ADDENDUM NO. THREE  
WARREN WOODS PUBLIC SCHOOLS  
Middle School Serving Line Renovation  
Page 1 of 1 (write up only)

January 12, 2022

ADDENDUM NO. THREE to the plans and specifications for the WARREN WOODS PUBLIC SCHOOLS, MIDDLE SCHOOL SERVING LINE RENOVATIONS, Warren, MI, Architect's Project No. 211918, dated December 20, 2021.

**1 ENLARGED REFLECTED CEILING PLAN**  
SCALE: 1/4" = 1'-0"

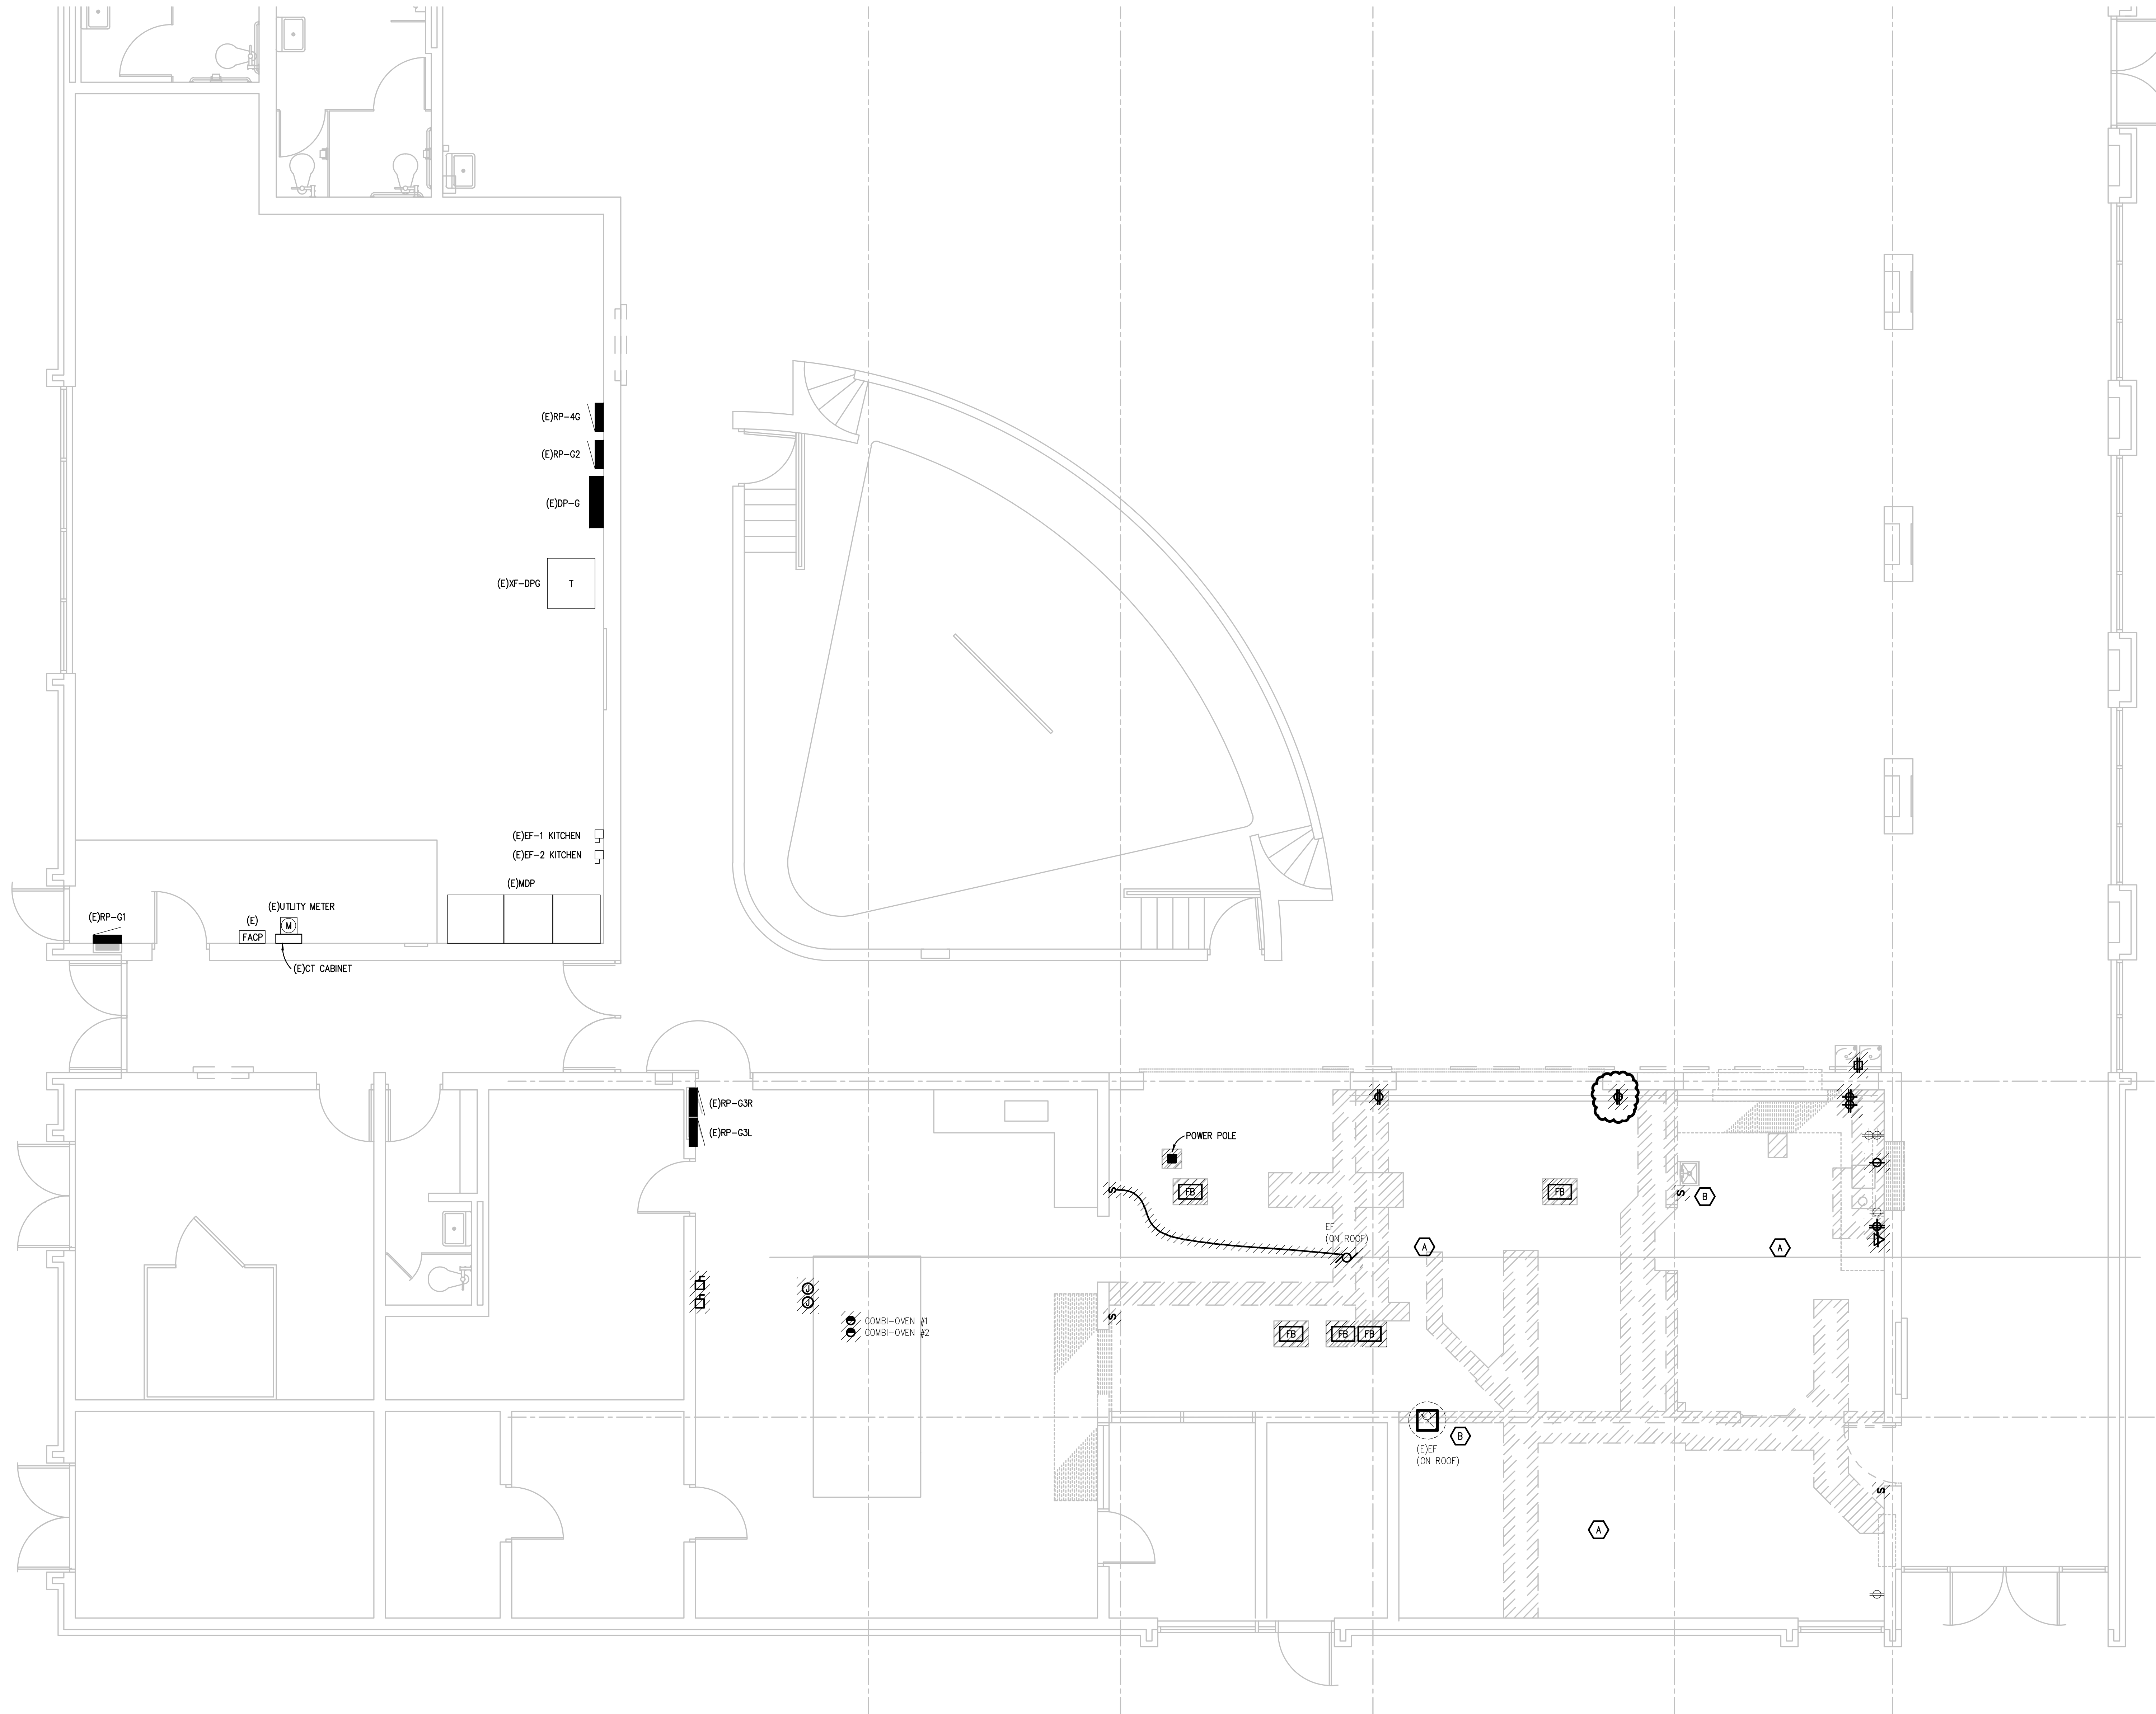
**ITEM NO. A1: Refer to Drawing A2.0 (re-issued)**

1. Added light fixtures in the reflected ceiling plan.

**ELECTRICAL DEMOLITION PLAN**  
 SCALE: 1/8" = 1'-0"

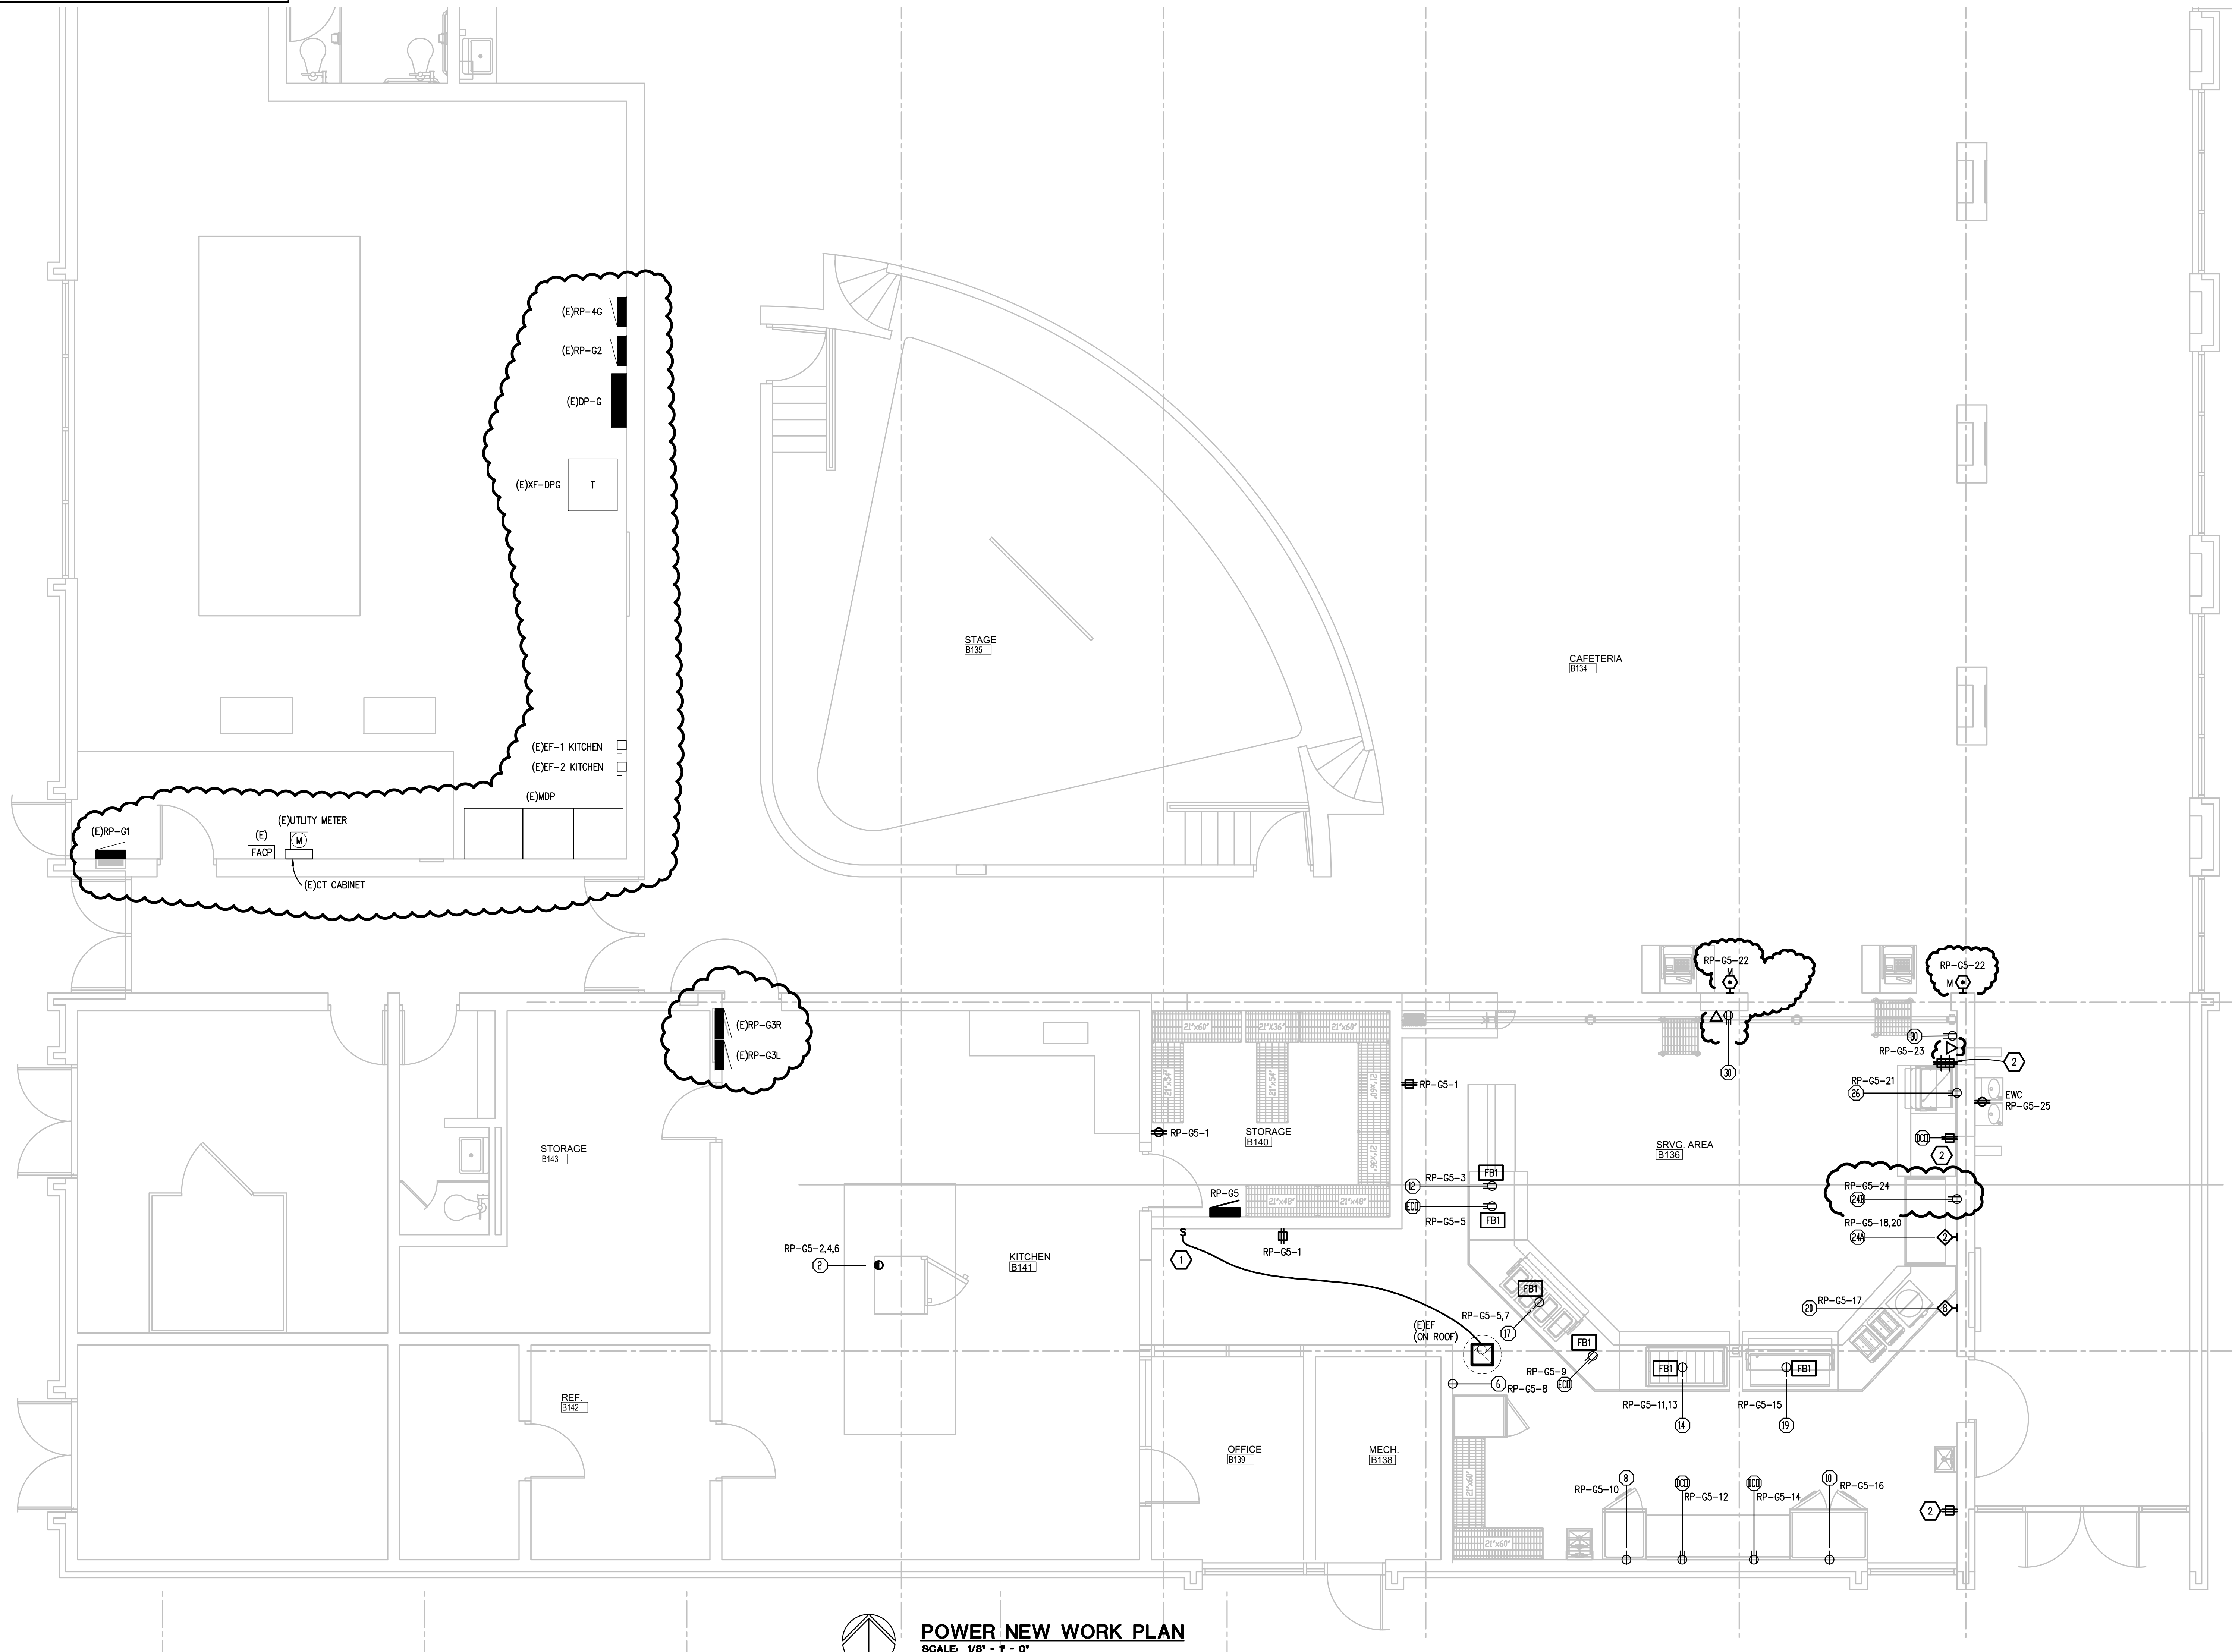
**ITEM NO. E1: Refer to Drawing ED1.00 (re-issued)**

1. Added receptacle to be demolished as indicated.

**POWER NEW WORK PLAN**  
SCALE: 1/8" = 1' - 0"

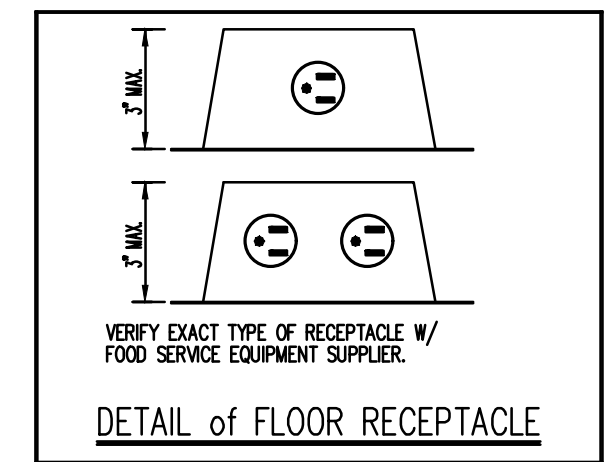
**ITEM NO. E2: Refer to Drawing E3.01 (re-issued)**

1. For clarification only, added existing Main distribution panel, transformer and branch panels, as indicated.
2. Relocated telecommunication outlets as indicated.
3. Removed Construction Keynote 2 for receptacle that was demolished.
4. Added circuit for FSE item 24B, as indicated.
